**TO:** T10 Membership  
**FROM:** Paul A. Suhler, Quantum Corporation  
**DATE:** 20 June 2006  
**SUBJECT:** T10/05-049r3, SSC-3 Physical Device Model

Figure X – UML description of physical device

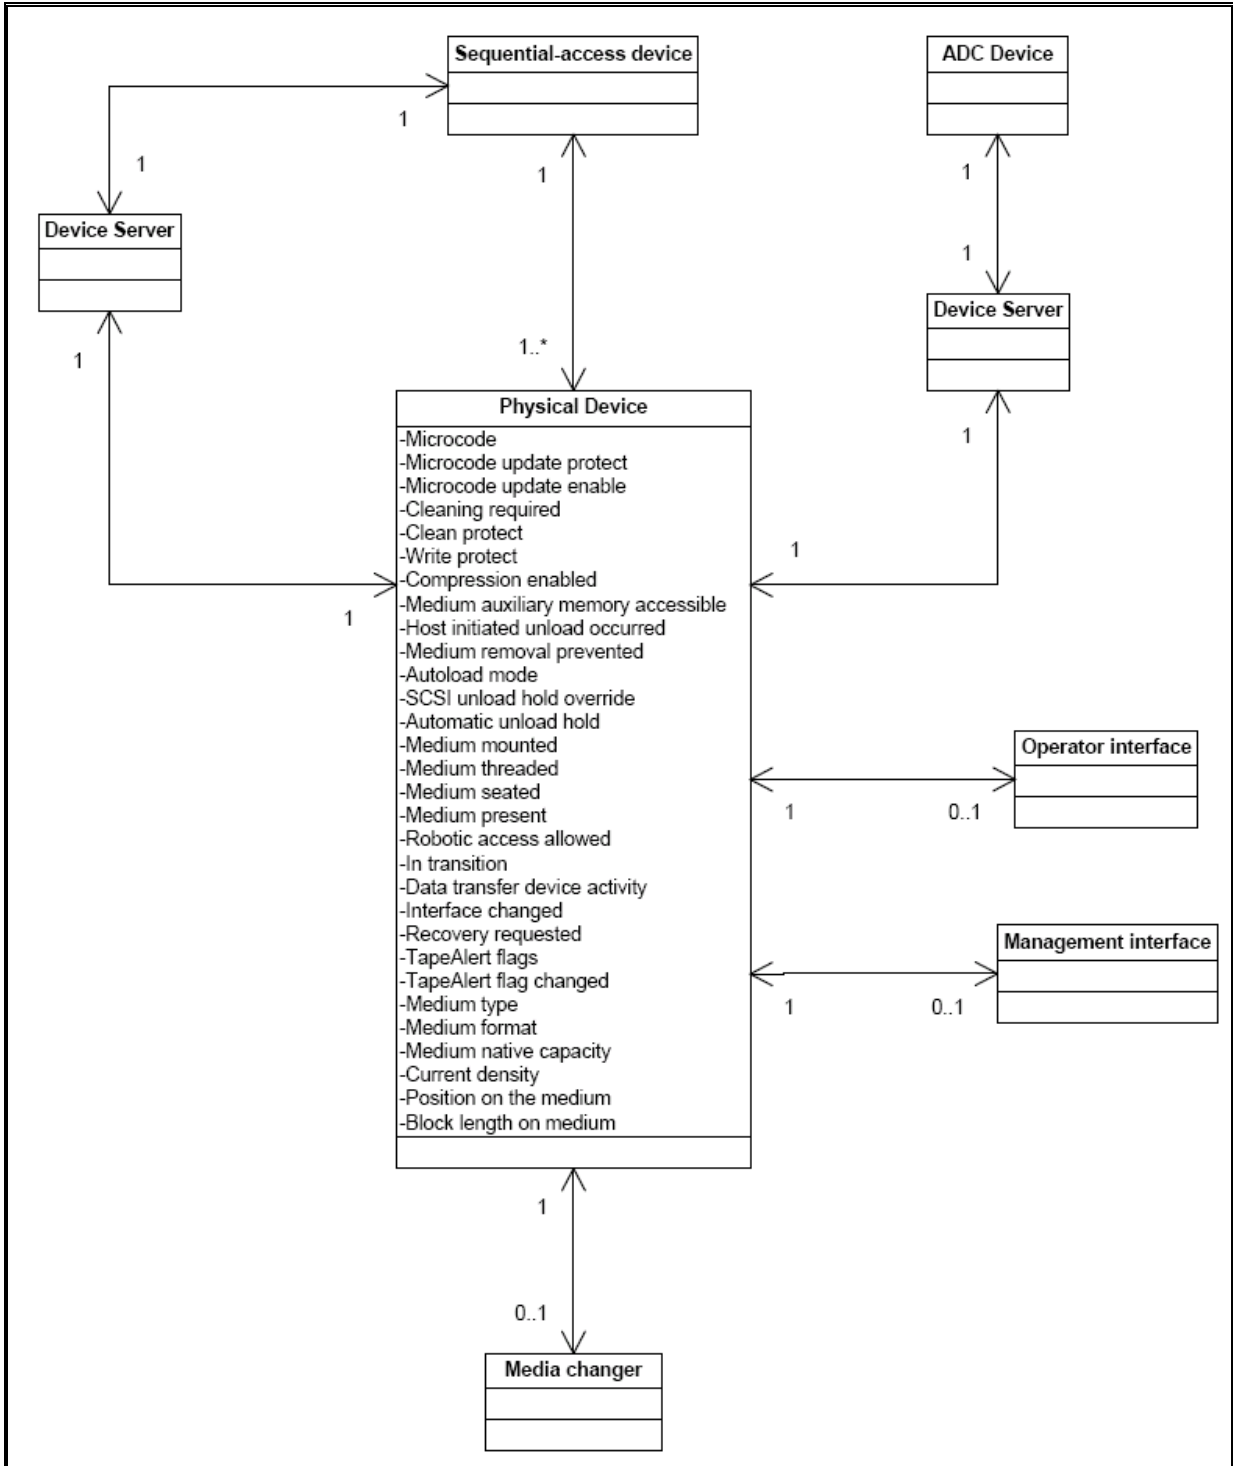
These entities perform operations that change various attributes of the physical device. These attributes affect the operations on a volume. Figure X shows in UML notation an example of the entities in a SCSI target device, and shows the attributes which comprise the physical device. The set of attributes implemented by a physical device is vendor-specific.
